Subject: Zion Station Units 1 and 2
Control of Heavy Loads Near Spent Fuel
NRC Docket Nos. 50-295 and 50-304

ATTACHMENT A

Partial Response to Request for Additional Information on Control of Heavy Loads

FIGURE 3-1

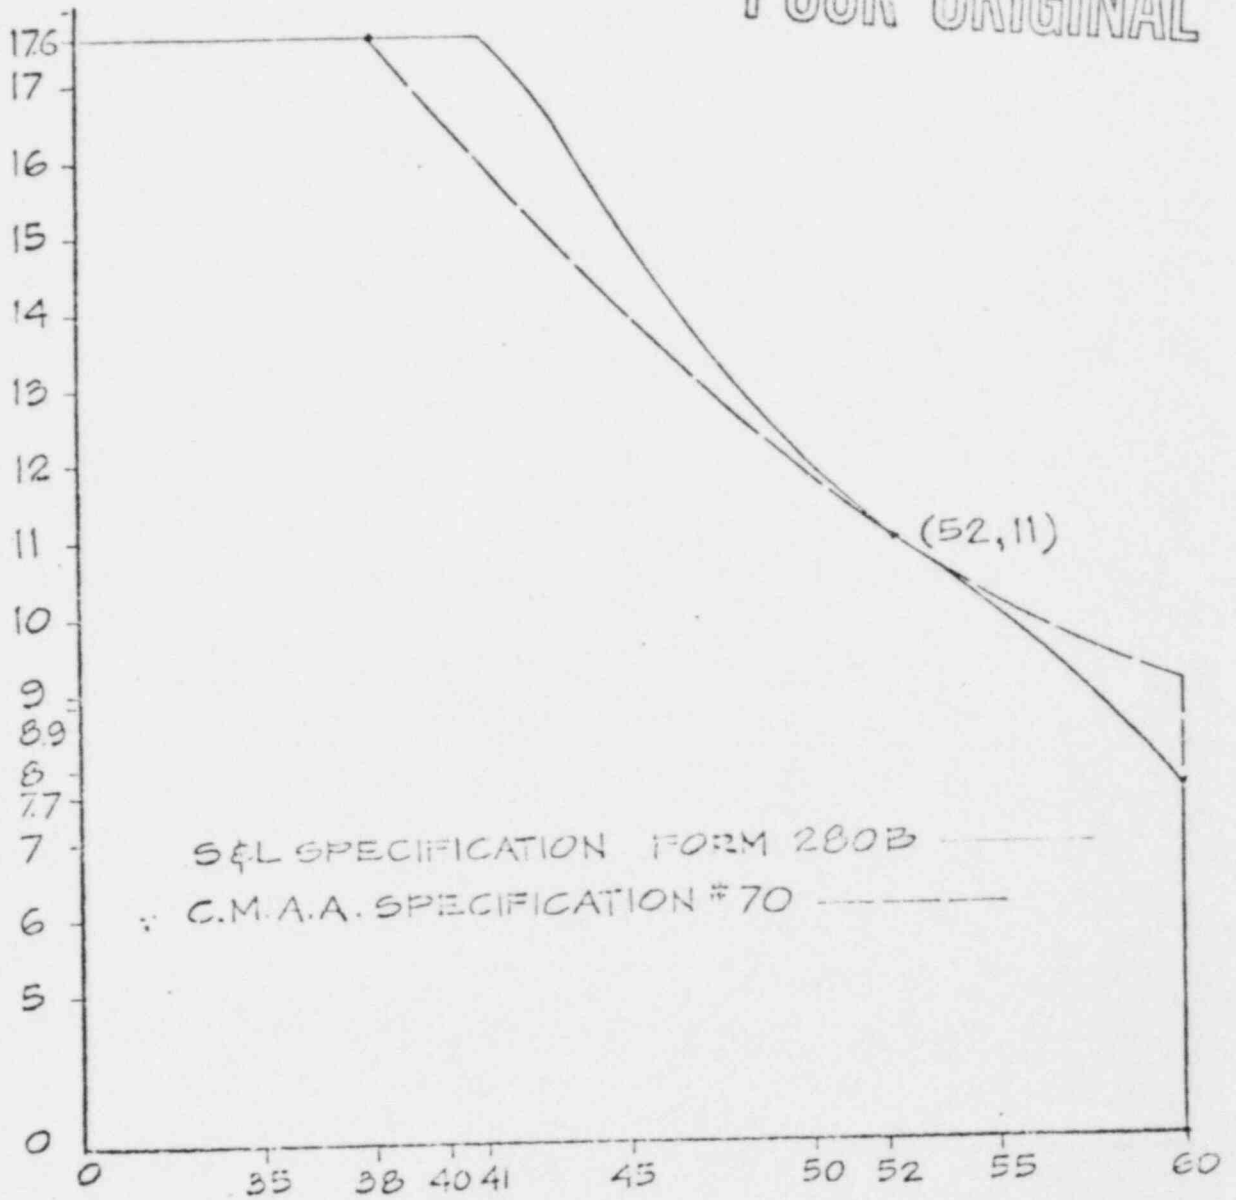
- 2) Compressive Stress: As shown in Table 3-3, the allowable compressive stress specified in Form 280B is identical to those specified by CMAA-70-1975 for members with non-slender compressive flange. A comparison of the allowable compressive stress criteria given in Form 280B and CMAA-1975 is shown in Figure 3-1. The box girders for the polar crane and the fuel handling building crane in Zion have a b/c ratio of 11 and 24, respectively. For these b/c ratios, these structural elements meet the requirements of CMAA-70-1975.
